HARVEST ROAD

48TH AVENUE TO 56TH AVENUE - INFRASTRUCTURE SITE PLAN

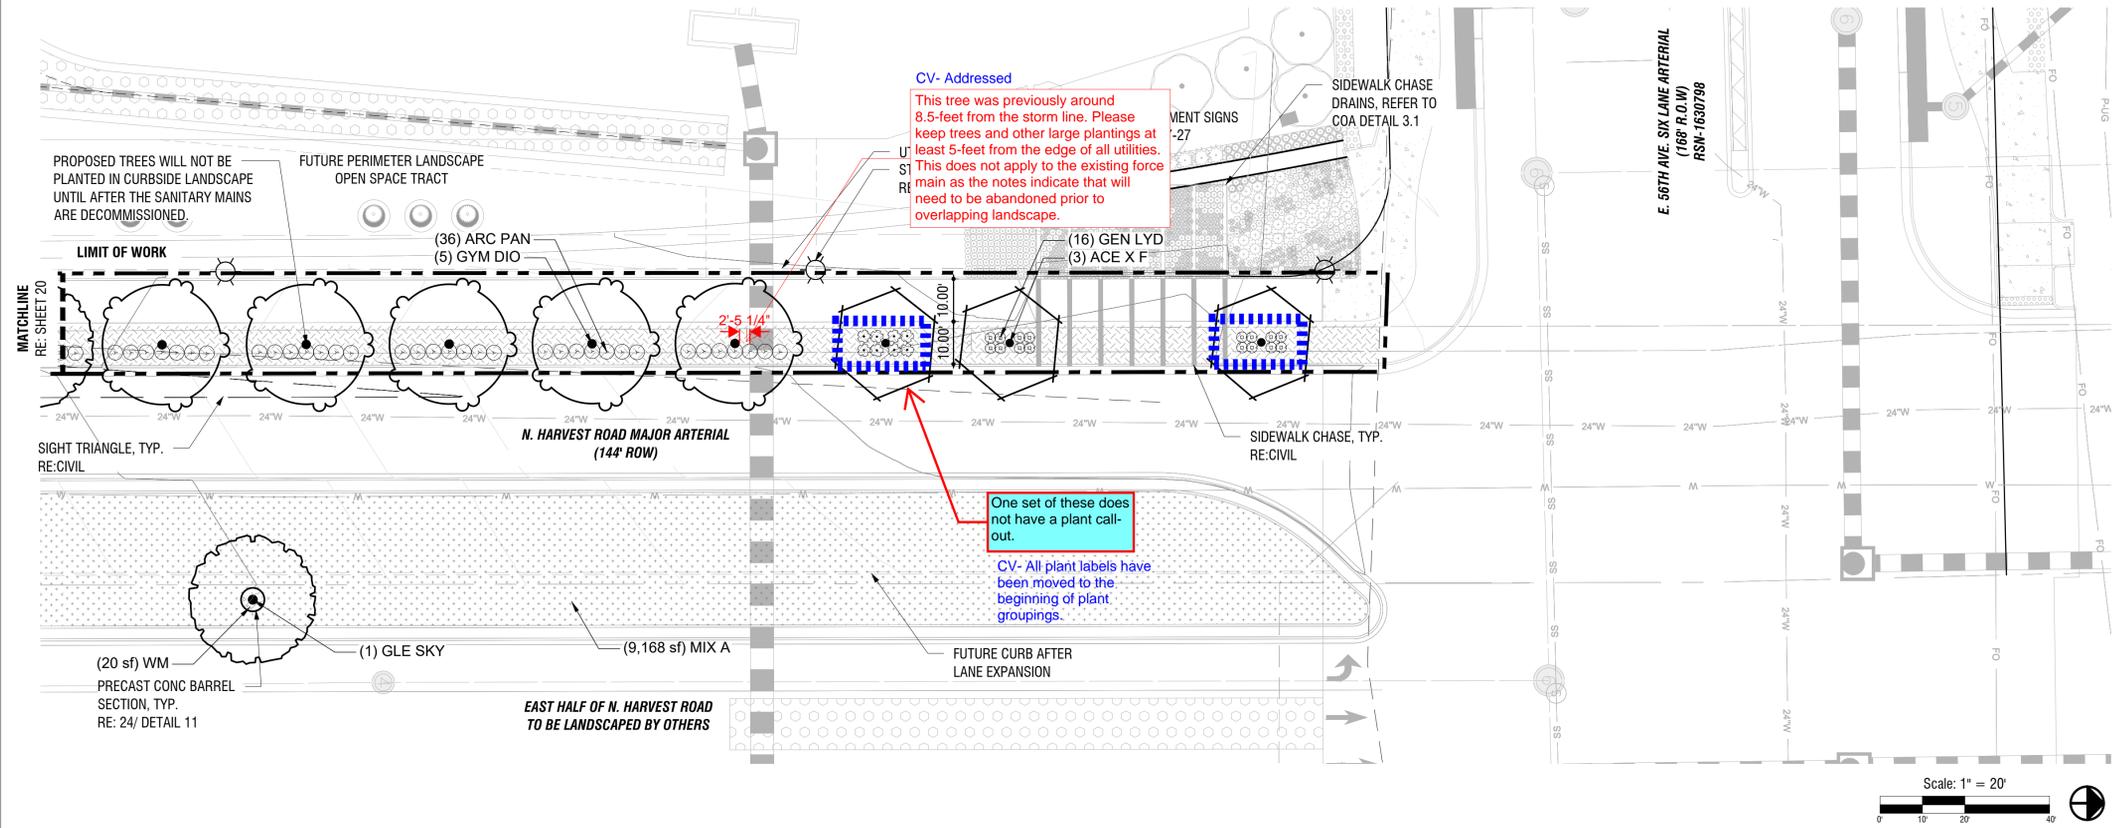
CV- Addressed
 This tree was previously around 8.5-feet from the storm line. Please keep trees and other large plantings at least 5-feet from the edge of all utilities. This does not apply to the existing force main as the notes indicate that will need to be abandoned prior to overlapping landscape.

One set of these does not have a plant call-out.
 CV- All plant labels have been moved to the beginning of plant groupings.
